Mitsubishi hoist

No. 855-0228

Notice of Grease Change of Traversing Deceleration Part

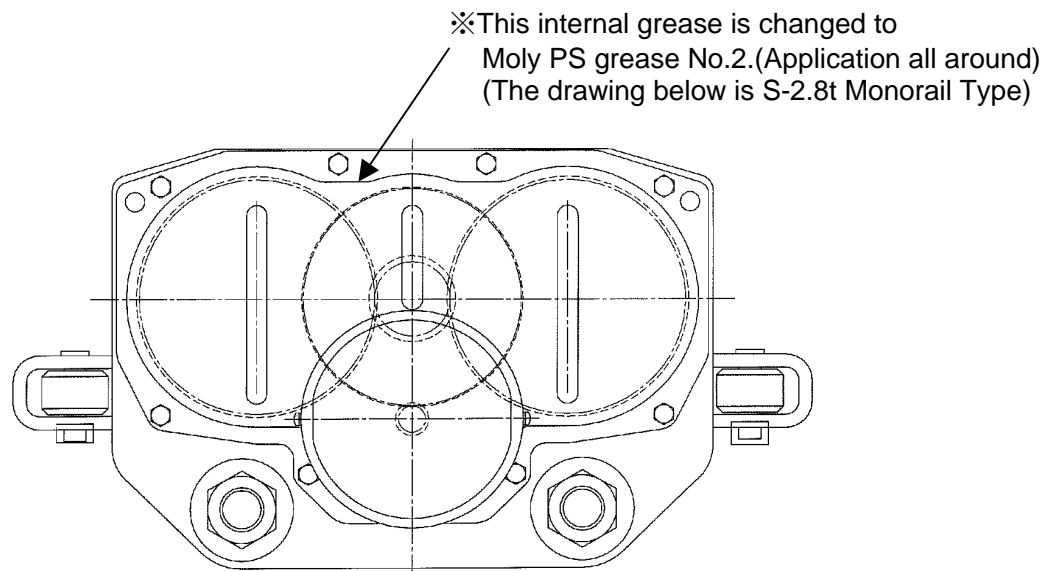
Changes (1)The lubricant(grease) for the traversing deceleration part is changed.

Before change	After change
Lubricant	Alvania EP-2 (Fill approx. 1/3 of the space)	Moly PS grease No.2 (Application all around)

(2) The ball bearings are changed to sealed type ball bearings. (ZZ)

The improvement for the lubricating ability and the quality.
